LINCOLN & DRANSFELDT

WATER AND SANITARY PLANS

ISSUE DATE: 08-16-2021	PROJECT #: 200829
DATE	REVISION COMMENTS
11-17-2021	PER PWSD COMMENTS

WATER LINE A PLAN
SCALE: 1" = 20'

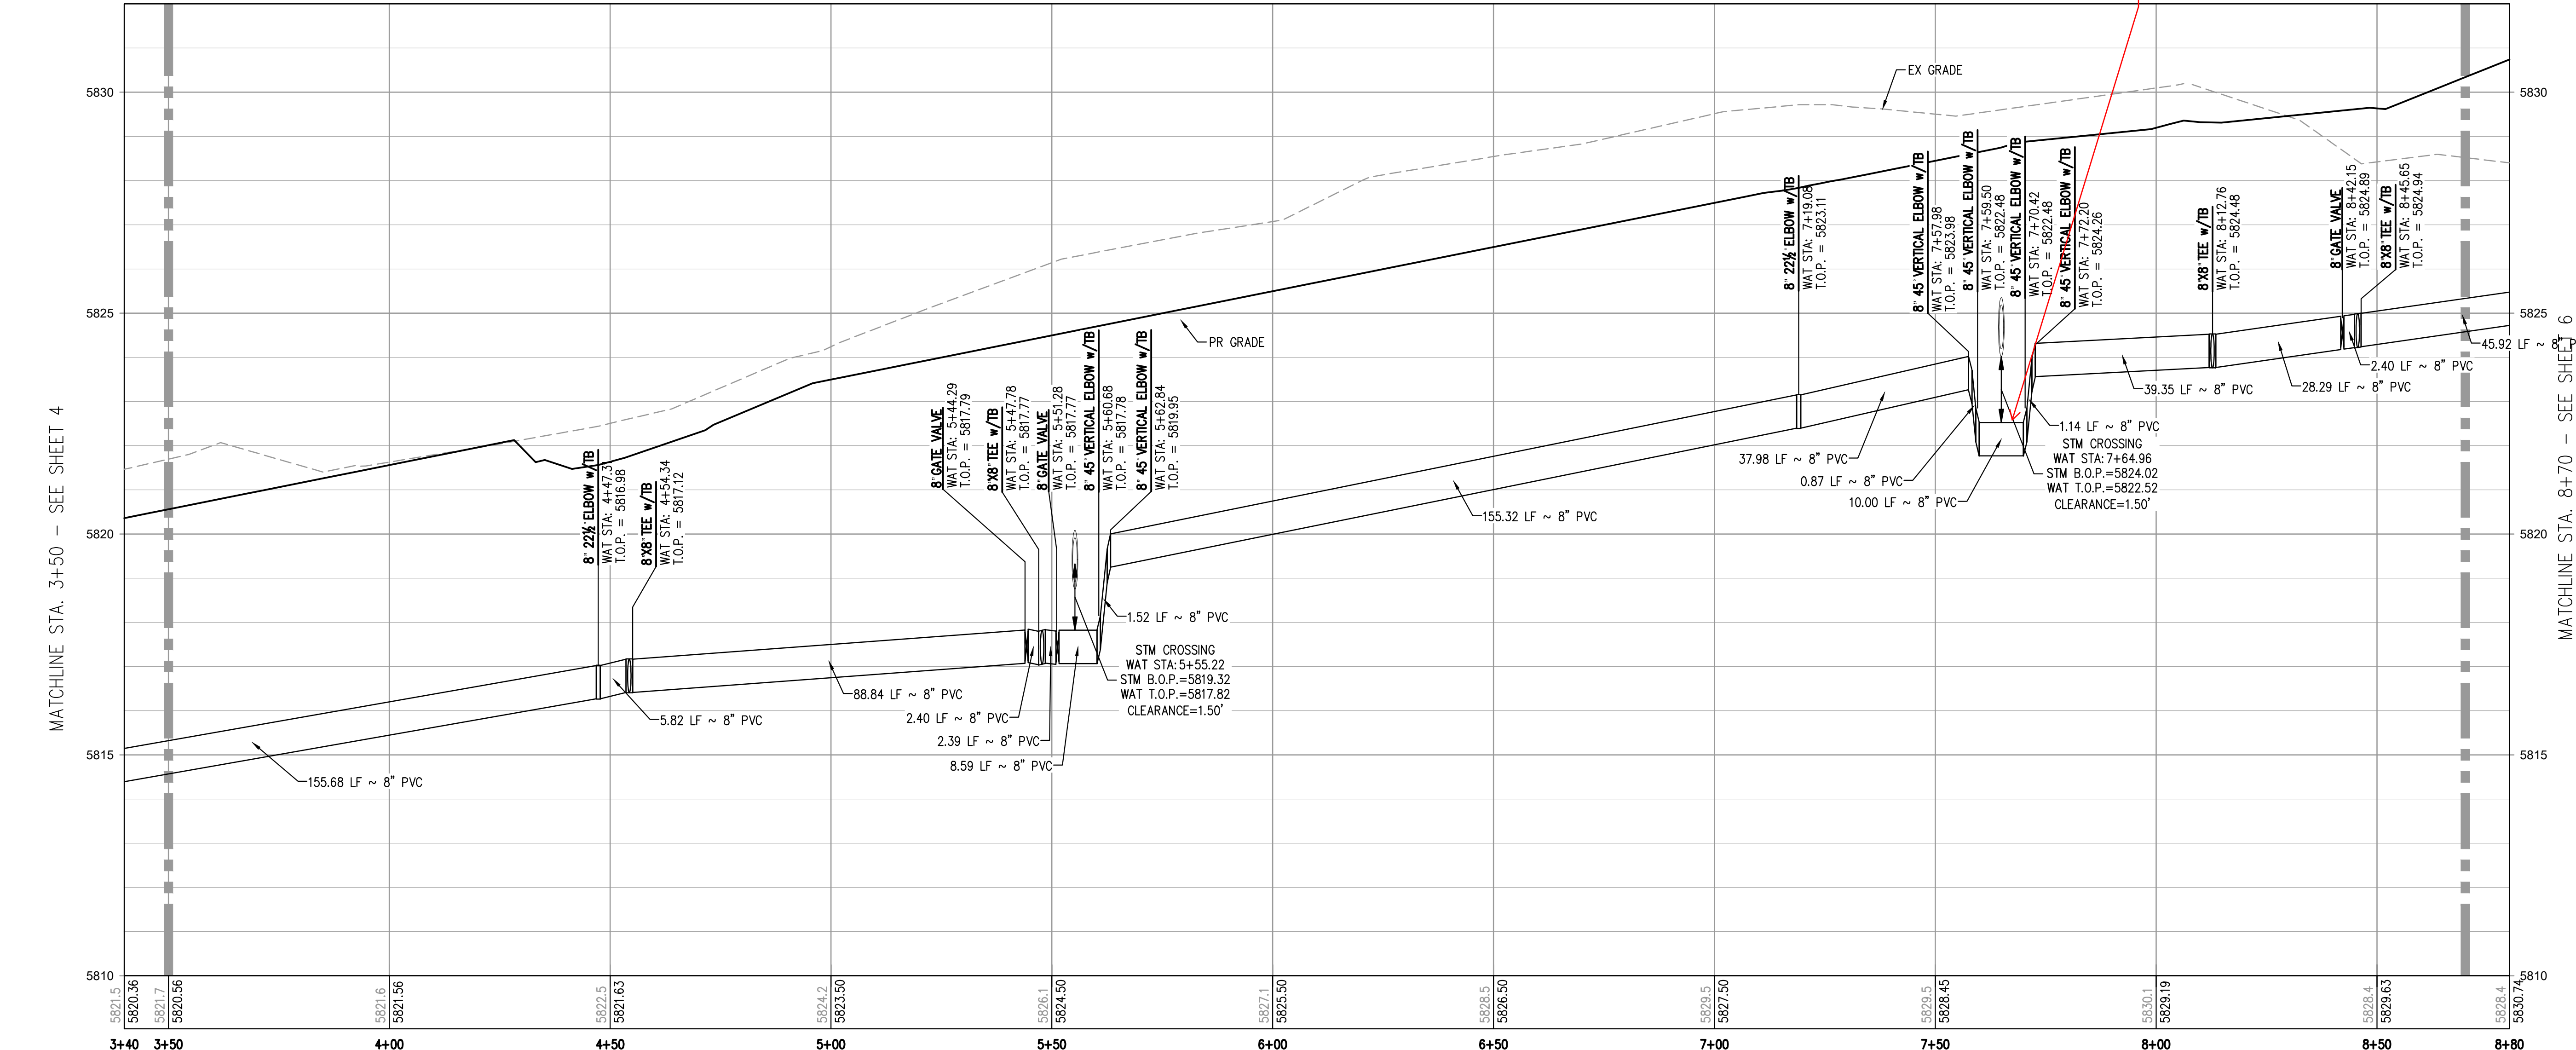
All lowering's require low point blow off valves.

LINCOLN & DRANSFELDT
 SANITARY PLAN & PROFILE

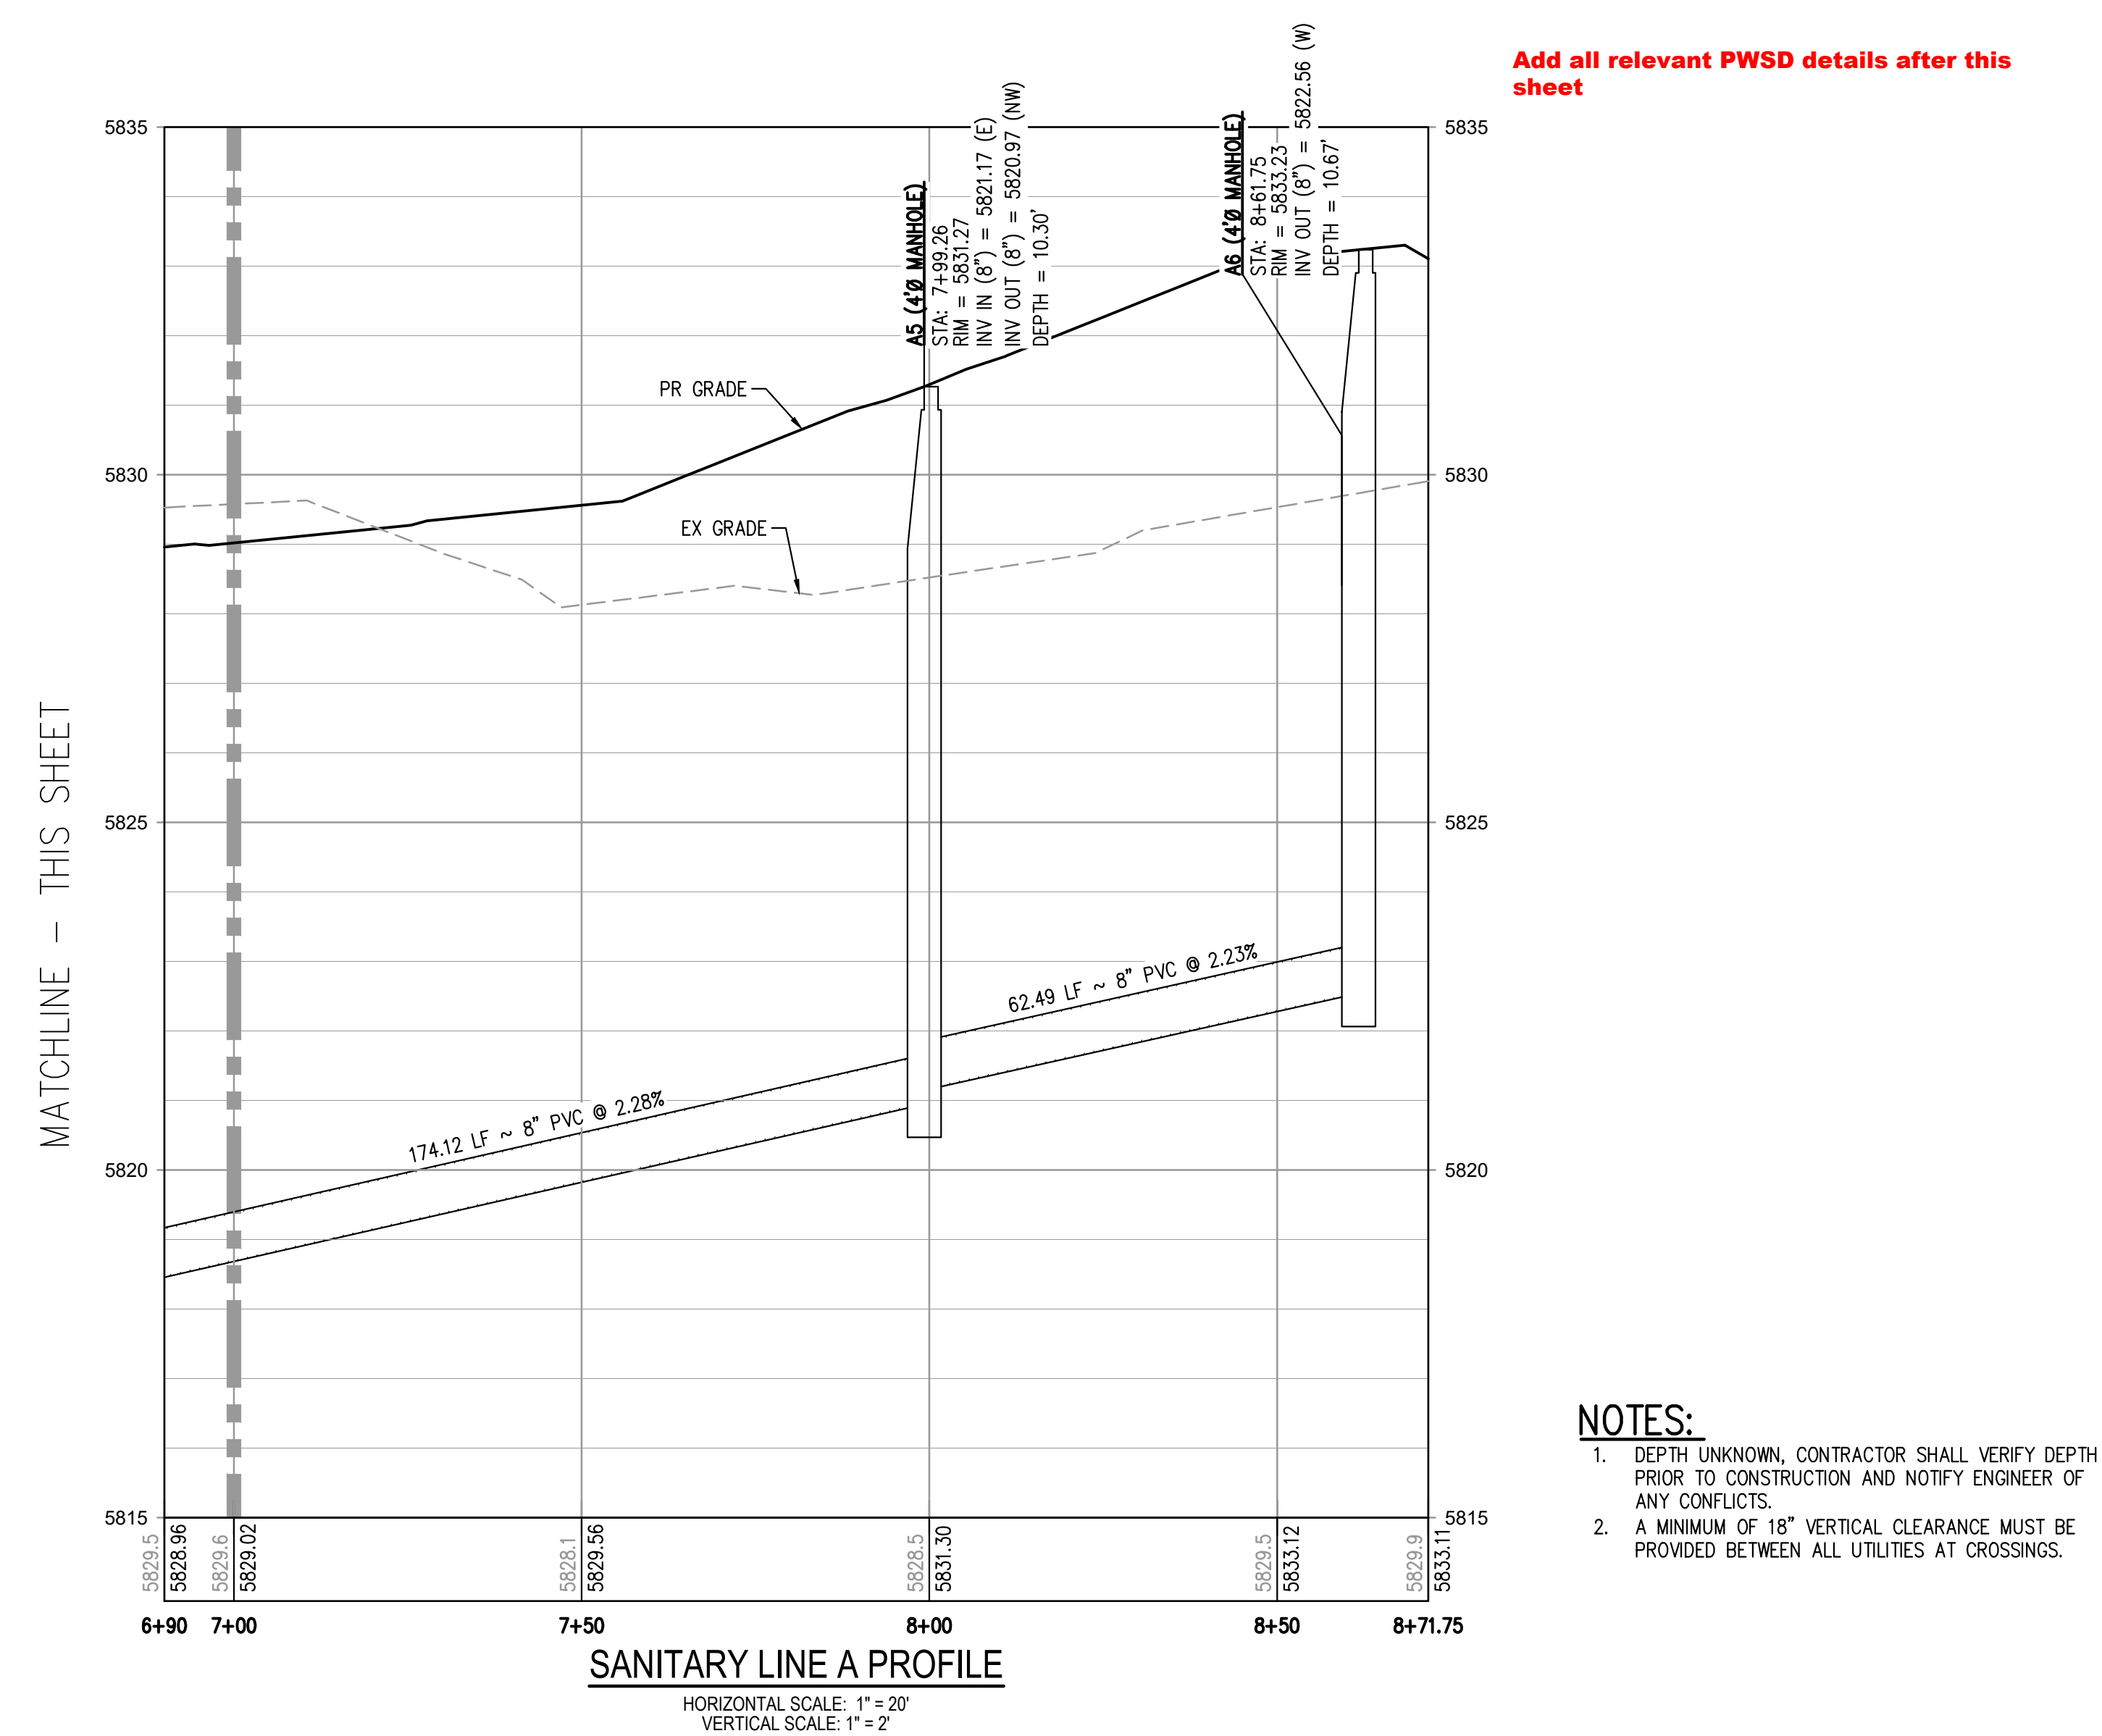
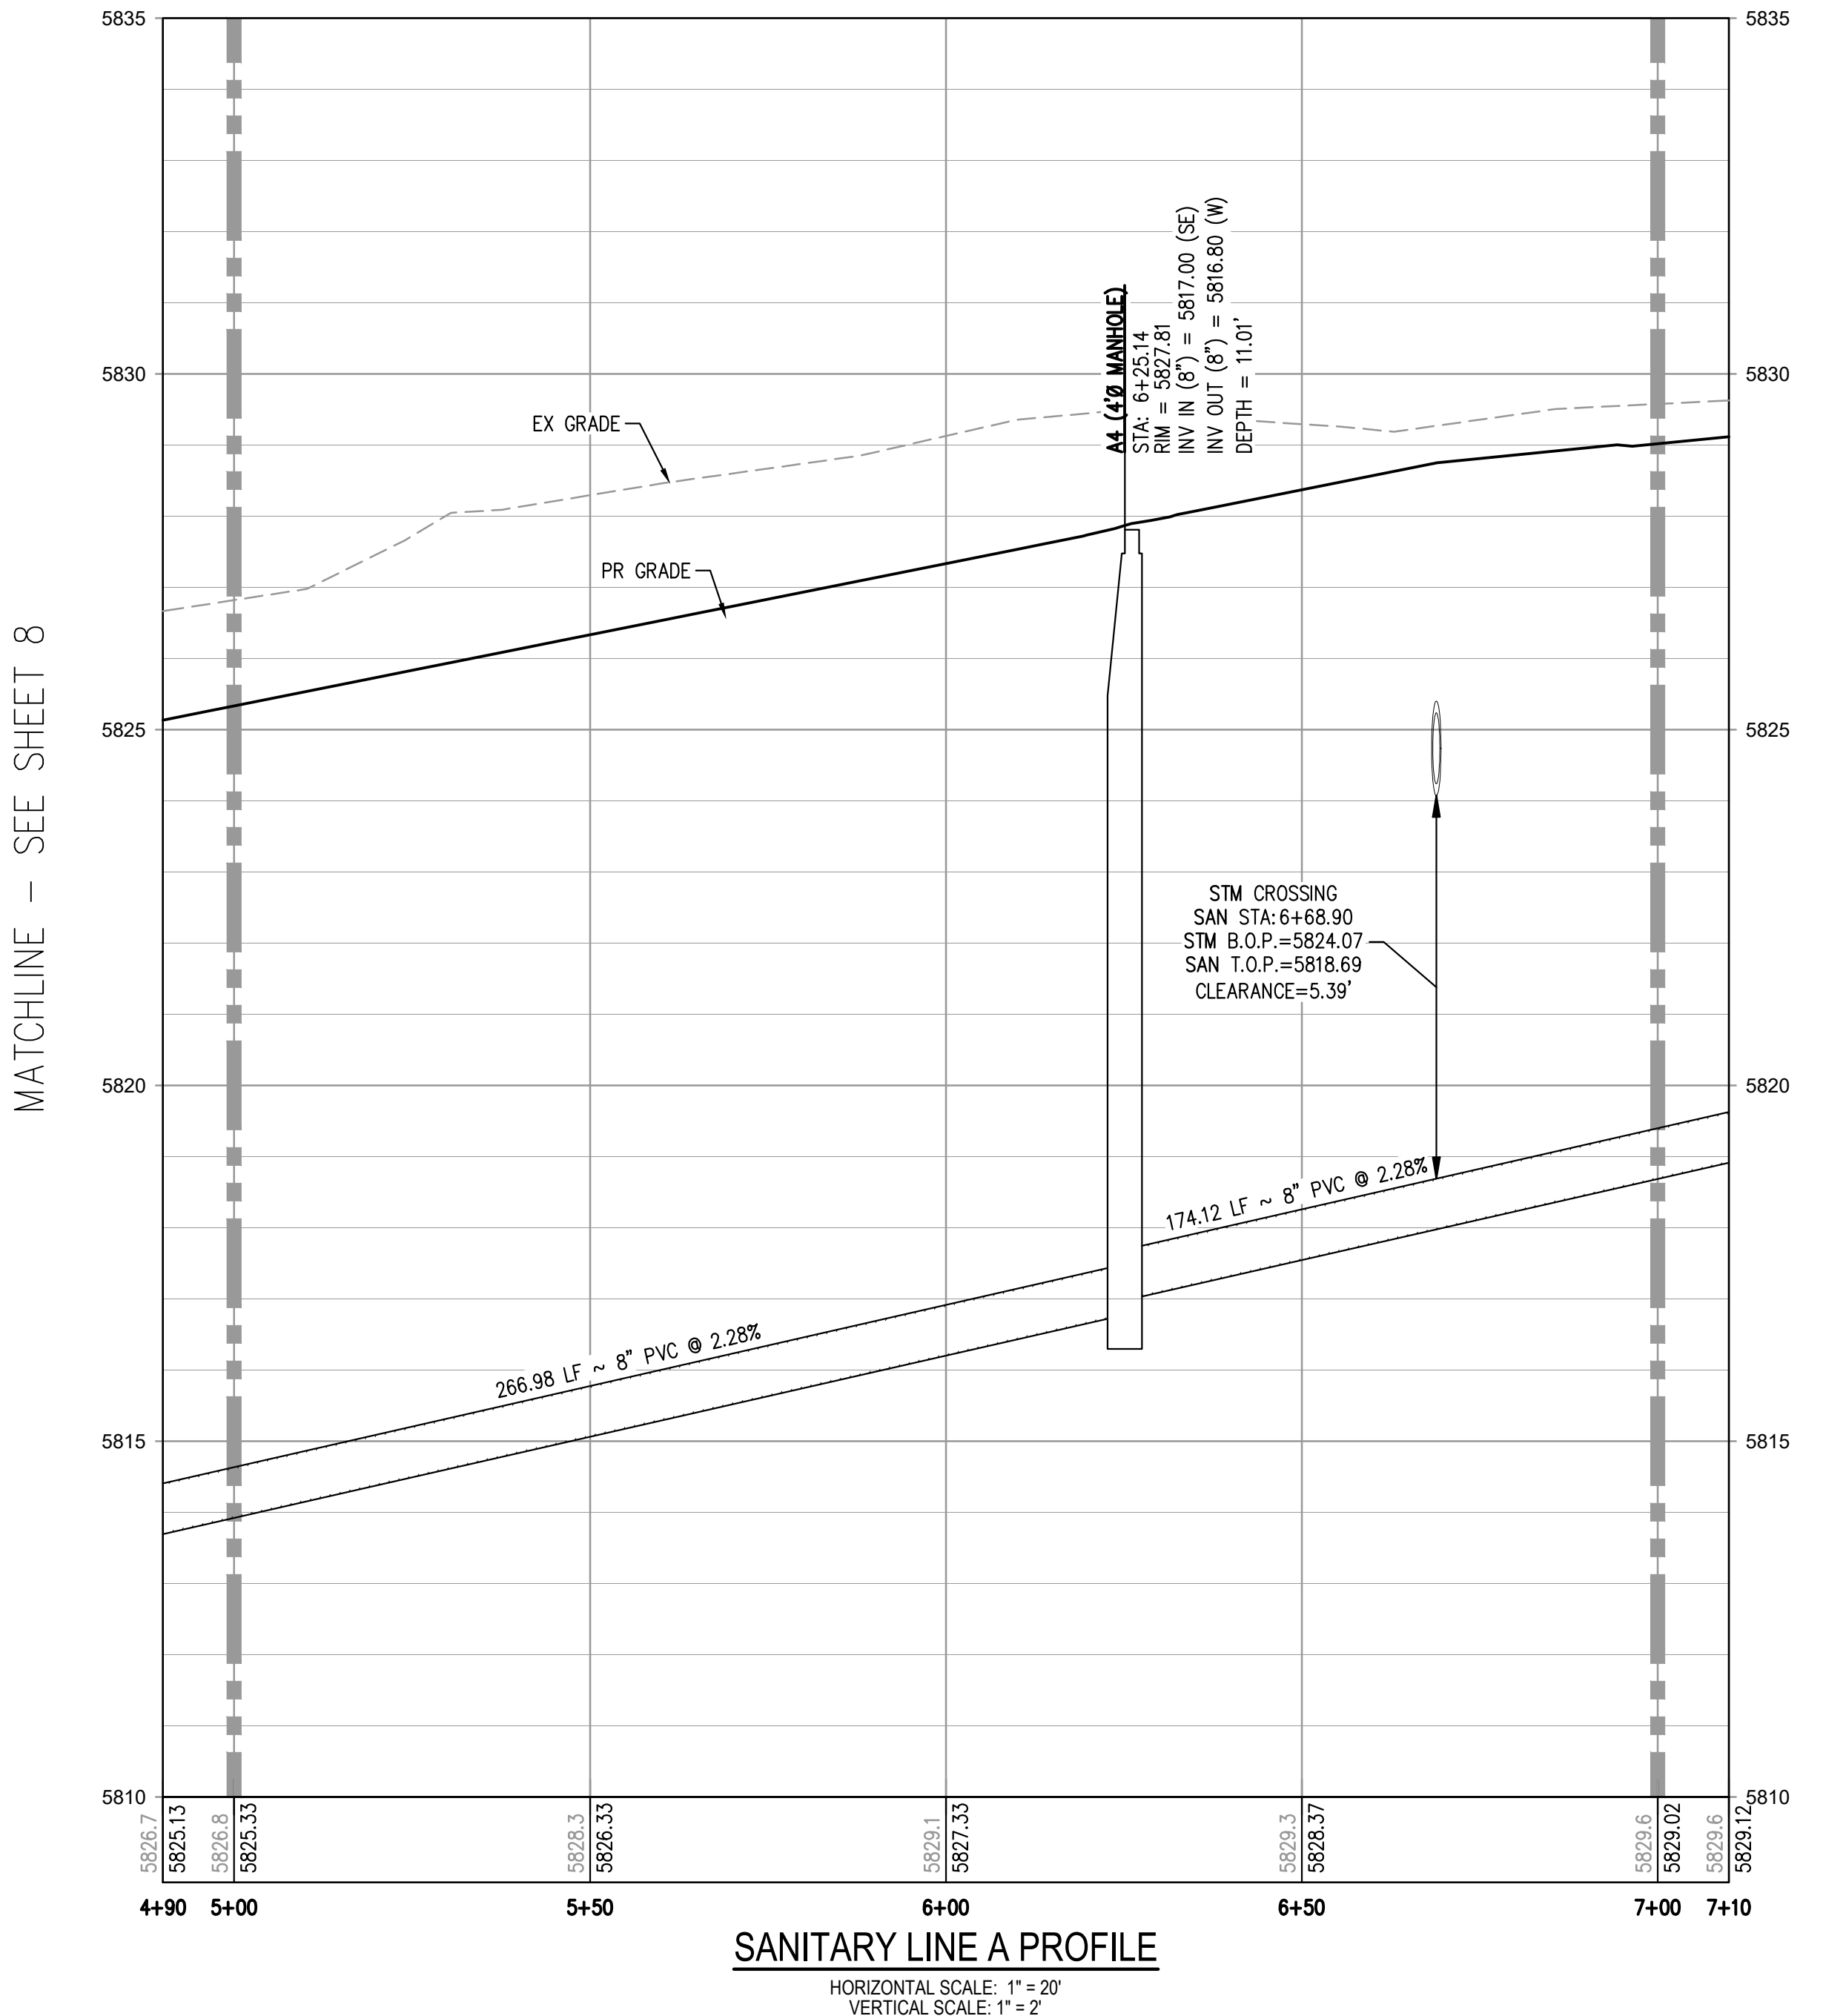
Add all relevant PWSO details after this sheet
